New York State Department of Environmental Conservation
Division of Environmental Remediation, Region 8
6274 East Avon-Lima Road, Avon, New York 14414-9519
Phone: (585) 226-5353 • FAX: (585) 226-8696
Website: www.dec.state.ny.us

Re: Fischbach & Moore Site
235 Metro Park
Site No. V00492-8
January 2006 Remedial Design Investigation Work Plan

The New York State Department of Environmental Conservation (NYSDEC), in coordination with the New York State Department of Health (NYSDOH), has completed its review of the January 2006 Remedial Design Investigation Work Plan (Work Plan) for the Fischbach & Moore site (Site) located at 235 Metro Park, Town of Brighton. Based upon the information and representations given in the Work Plan, the additional investigation work can be performed with the following modifications and clarifications.

MODIFIED FIGURED #1

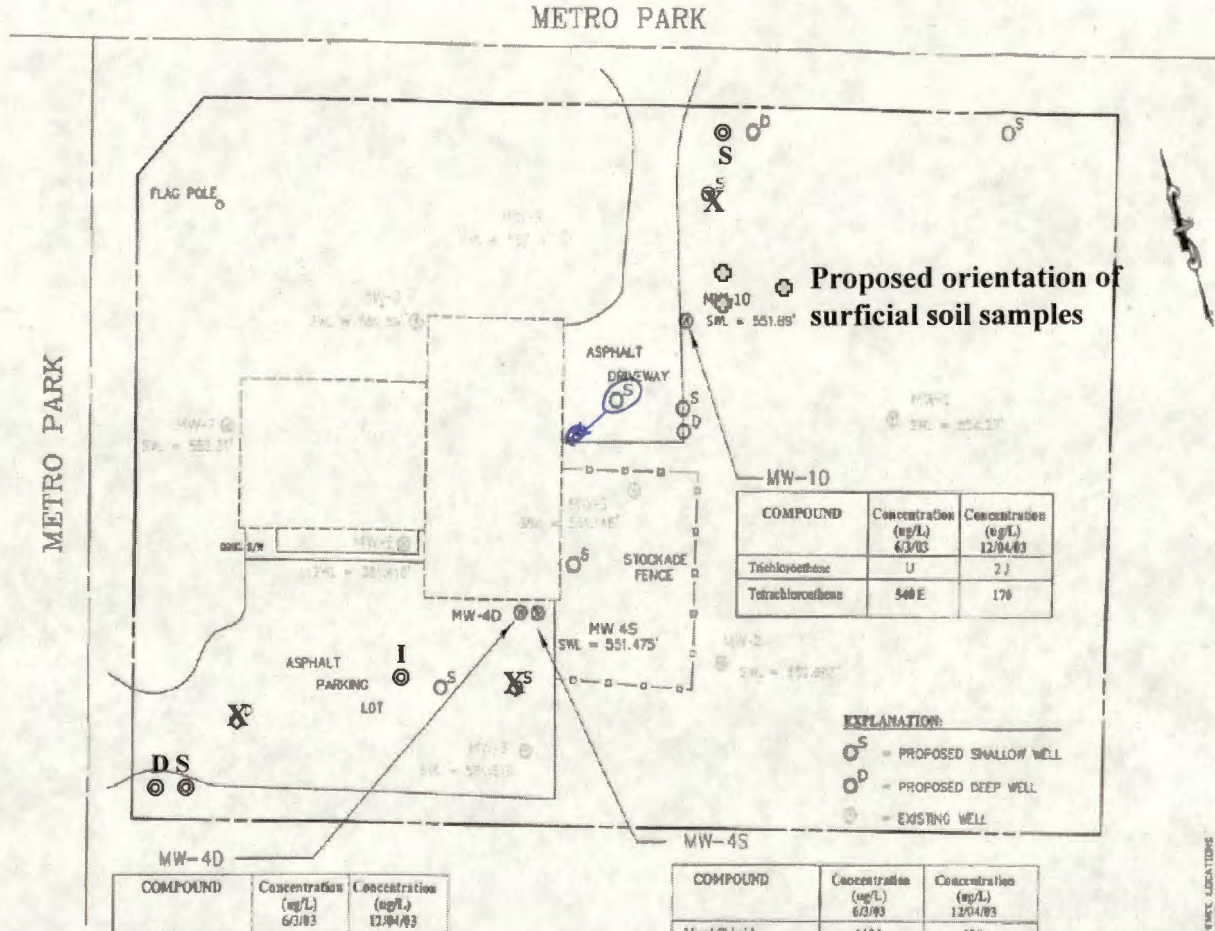
1. A modified Figure #1 (Attachment #1) shows the proposed alternate locations for certain shallow, intermediate, and deep groundwater monitoring wells at the Site. Typically shallow and deep monitoring wells are clustered together. See modified Figure #1 for the proposed location of the monitoring wells. The locations shown on the modified Figure #1 are approximate and will be subject to field conditions.

An intermediate monitoring well is needed to evaluate the zone between the shallow and deep wells. The Test Boring Report for MW-4D indicates that there is a plastic clay layer located between 55-60 feet at the Site. Consider constructing the intermediate monitoring well such that the bottom of the monitoring well is sitting on top of the plastic clay layer. This interval should allow for the evaluation of the groundwater in the zone between the shallow and deep monitoring wells. The placement and depth of the intermediate monitoring well will be subject to field conditions.

Based on information presented in the Voluntary Cleanup Site Investigation Addendum (April 2005) and the revised Site Investigation Report (December 2005), there have been two different explanations presented regarding the elevated levels of polycyclic aromatic hydrocarbons (PAHs) detected at the Site: tar or asphalt pieces in the original soil samples and leachate from nearby asphalt covered surfaces. Surficial #7 should be re-sampled to determine if the elevated PAHs are contaminants of concern relative to Fischbach & Moore activities. The re-sampling of Surficial #7 should include 3 sample locations in a triangular formation: two (2) sample locations approximately 10 feet from the paved driveway and 10 feet apart. The third sample location located 20 feet from the paved driveway. See modified Figure #1 for the proposed orientation of the surficial soil sample locations.
